Plan Commission MEETING AGENDA

June 3, 2024 - 6:00 PM
Council Chambers
3805 S. Casper Drive

D.R.C. RECOMMENDATION: Public Hearing and Approval of the Conditional Use Permit, including the waiver request, for Elite Exteriors LLC to construct a new office/service commercial building located at 17400 W. National Avenue, subject to the application, plans on file and the following conditions of approval:

CITY OF NEW BERLIN
DEPARTMENT OF COMMUNITY DEVELOPMENT
PLAN COMMISSION STAFF REPORT

C3.0

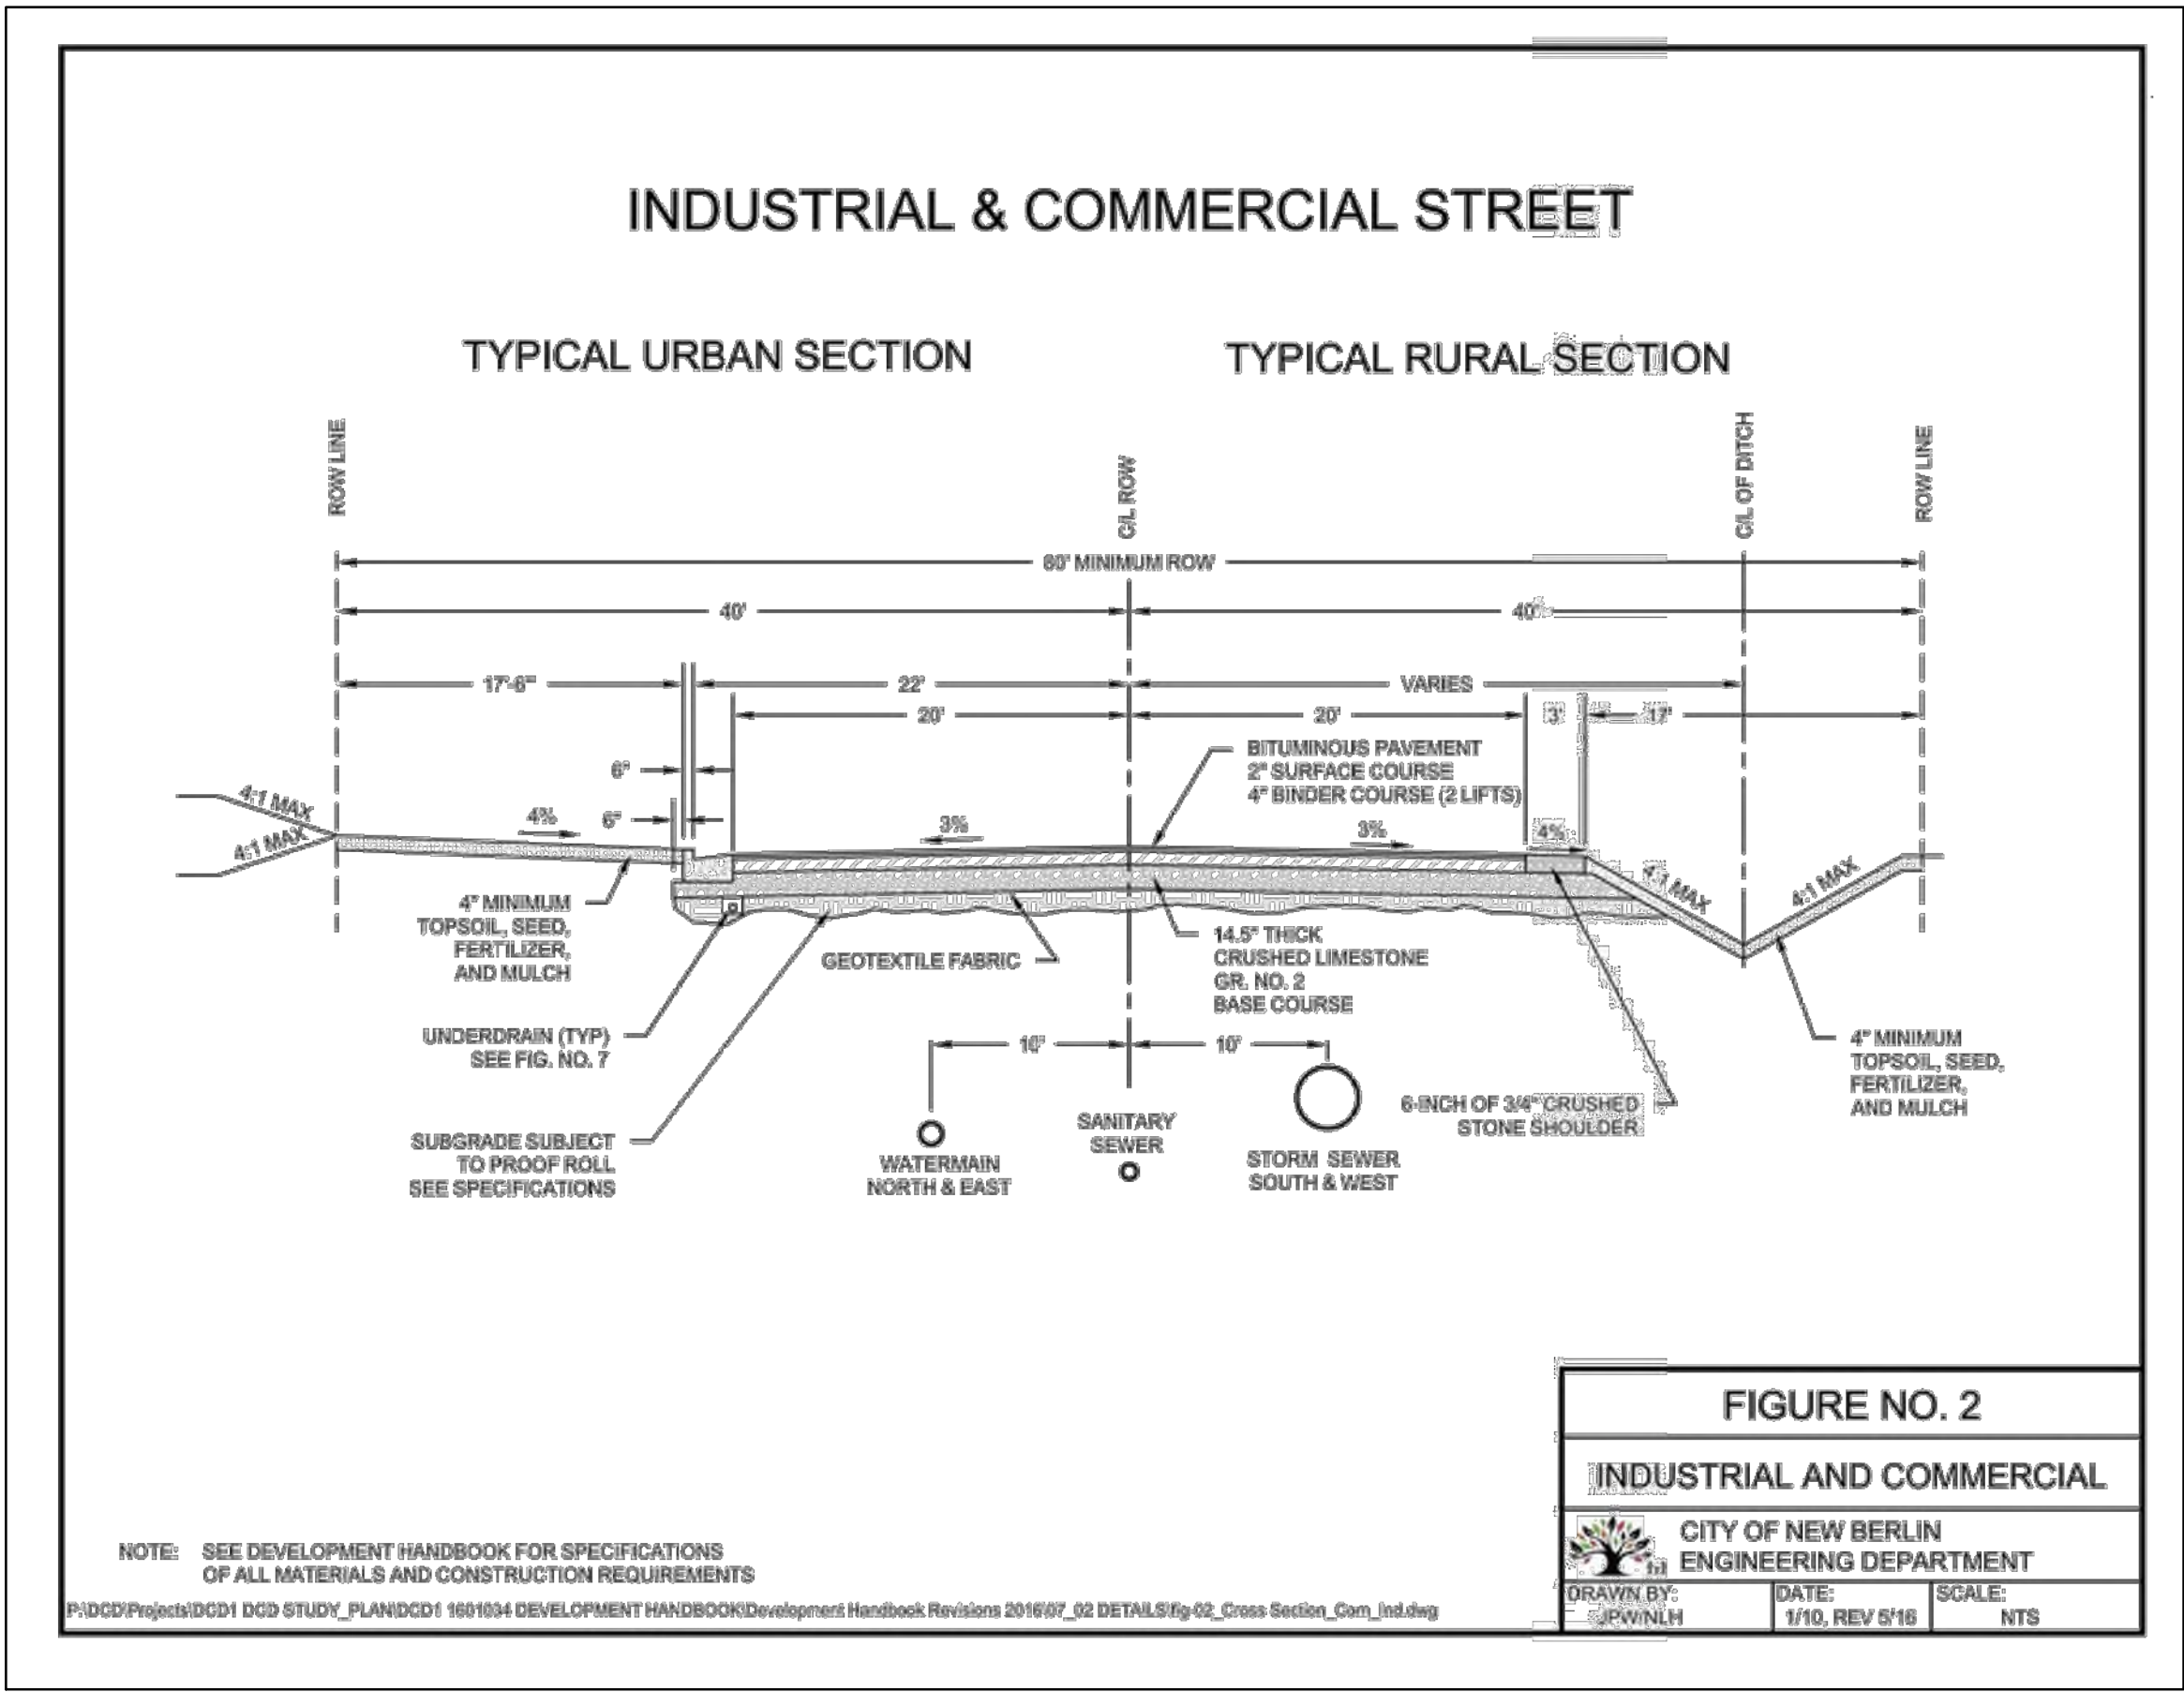
- k. Sheet C3.0:
 - i. Erosion Control Note #1. Change City of Pewaukee to City of New Berlin
 - ii. Erosion Control Note #2. Change City of Pewaukee to City of New Berlin
